SUBJECT: CHANGES TO TECHNICAL SPECIFICATIONS TO INCREASE MAXIMUM CONCENTRATION OF SODIUM PENTABORATE (TAC NOS. 65157 AND 65158)

RE: SUSQUEHANNA STEAM ELECTRIC STATION, UNITS 1 AND 2

AMENDMENT TO FACILITY OPERATING LICENSE

Amendment No. 69
License No. NPF-14

Figure 3.1.5-1

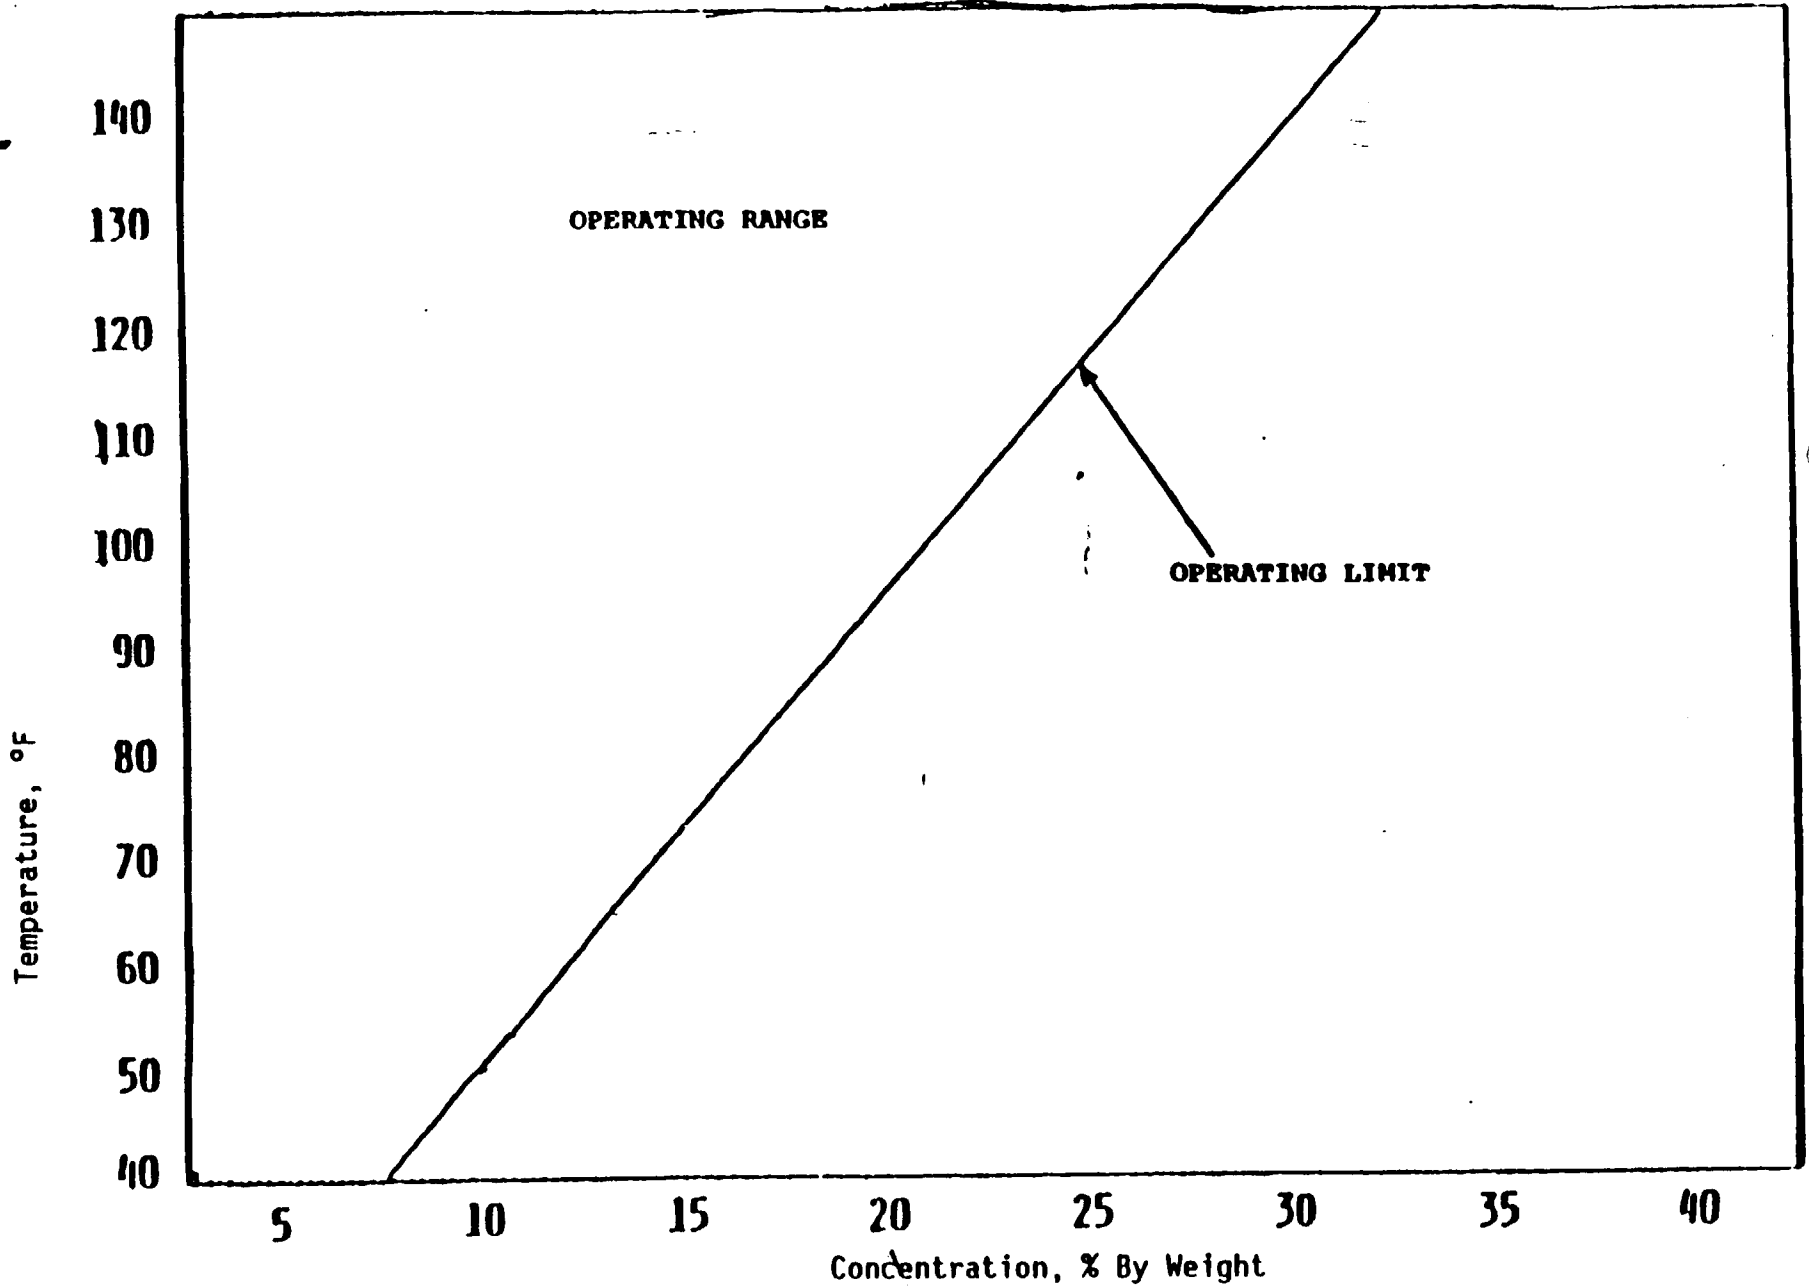
Replace the following page of the Appendix A Technical Specifications with enclosed page. The revised page is identified by Amendment number and contains vertical lines indicating the areas of change. The overleaf page is provided to maintain document completeness.*

In order to change the TS maximum allowable sodium pentaborate solution concentration for the SLCS from 13.8 weight percent to 15.8 weight percent to increase the band of design margin for the SLCS concentration, the licensee proposed to raise the piping heat trace setting from 80°F to 90°F. This will account for the increase in saturation temperature of the solution from 59°F at a concentration of 13.8 percent (current value) to 70°F at a concentration of 15.8 percent while maintaining a margin of at least 10°F. The margin is reflected in the solution temperature versus concentration curve. The licensee has also stated in a telecon that a heat trace trouble alarm is located in the main control room to alert operators to low temperature conditions which could lead to precipitation of the poison. The staff finds that the proposed change is consistent with the guideline given in the staff's standard review plan, and is, therefore, acceptable.

FIGURE 3.1.5-2
SODIUM PENTABORATE
SOLUTION CONCENTRATION

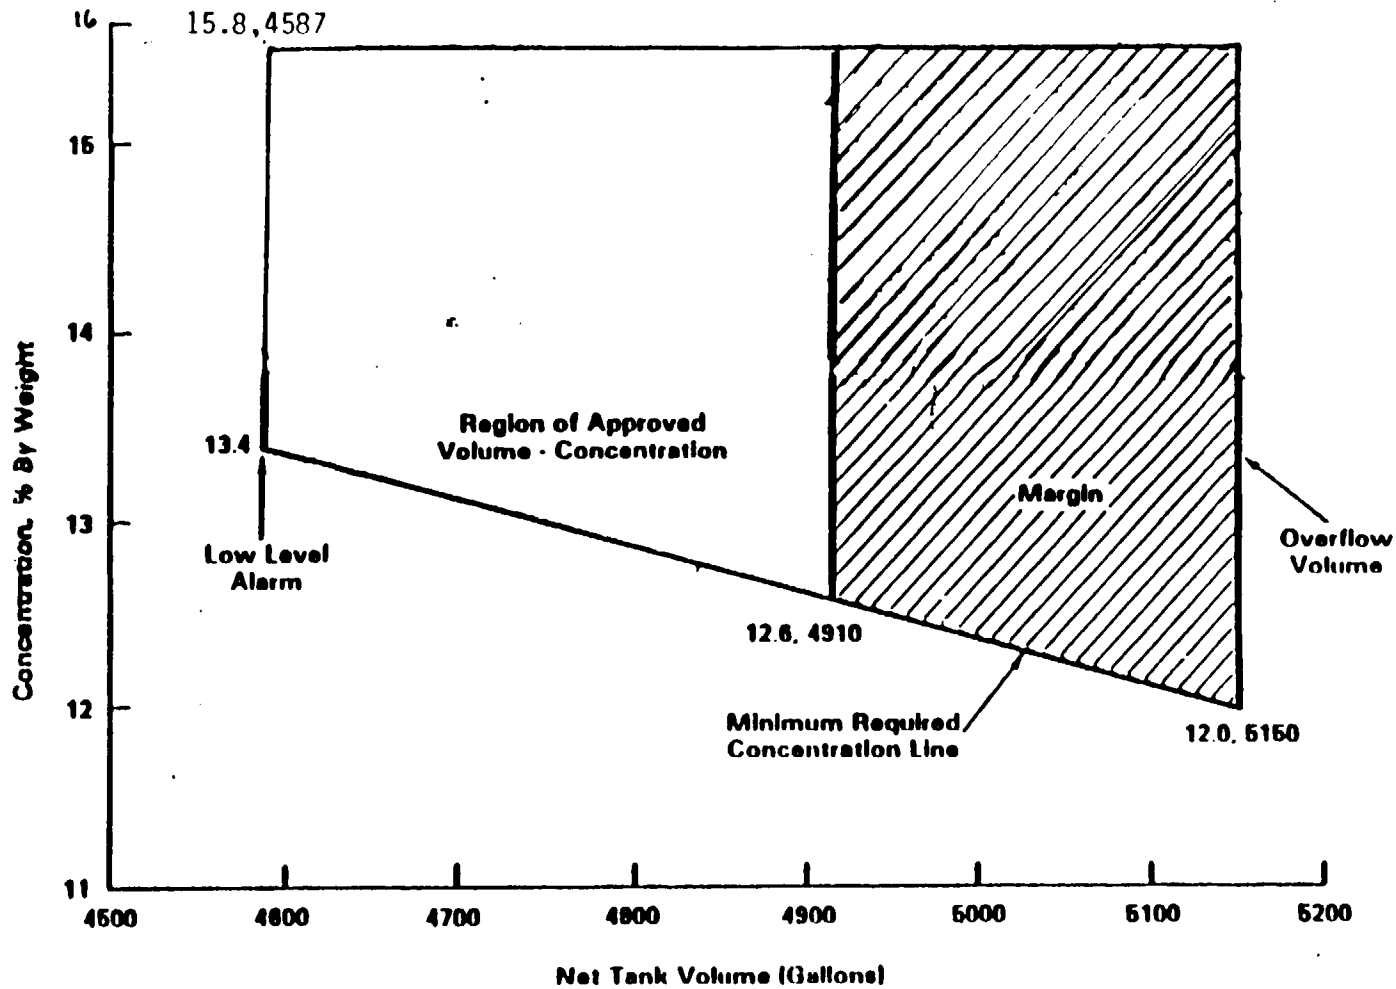
These amendments revise the SSES Unit 1 and Unit 2 Technical Specifications with regard to Sodium Pentaborate concentration in the Standby Liquid Control system.

FIGURE 3.1.5-1

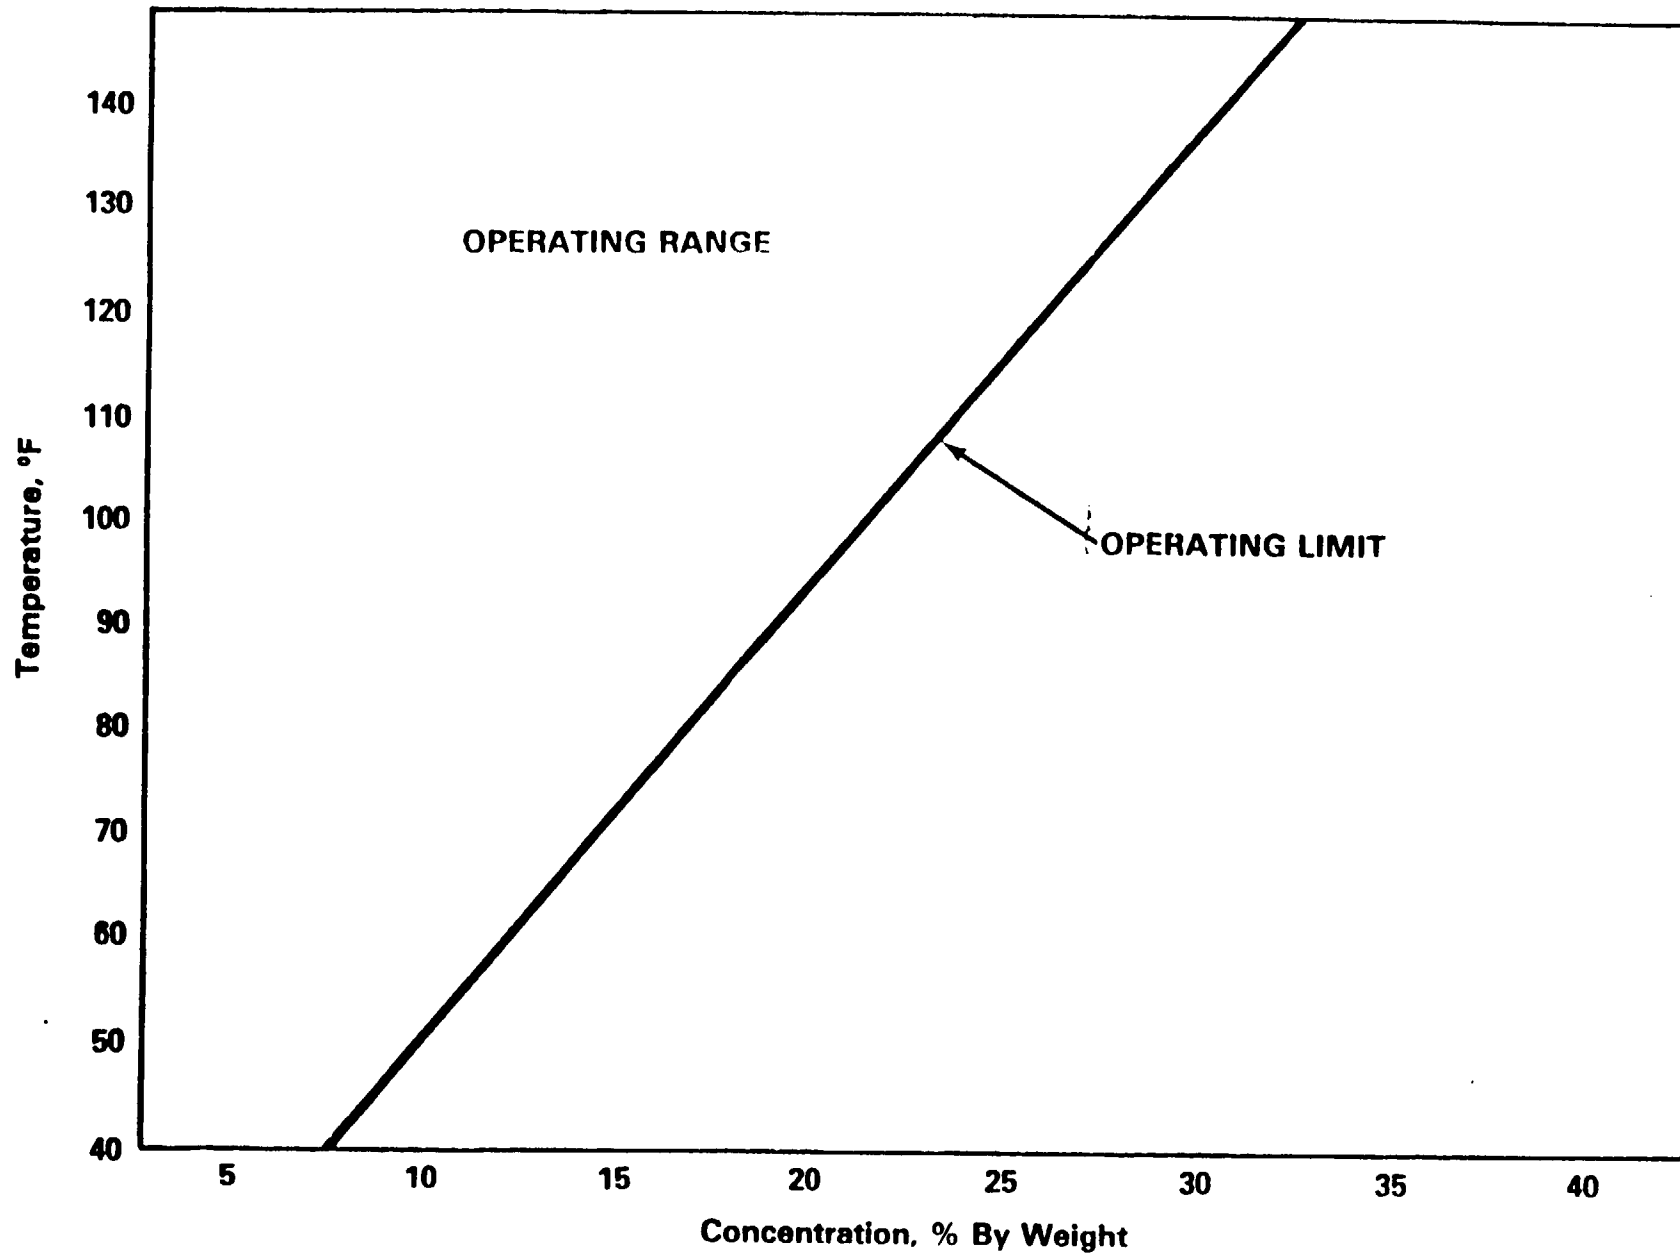
Replace the following page of the Appendix A Technical Specifications with enclosed page. The revised page is identified by Amendment number and contains vertical lines indicating the areas of change. The overleaf page is provided to maintain document completeness.*
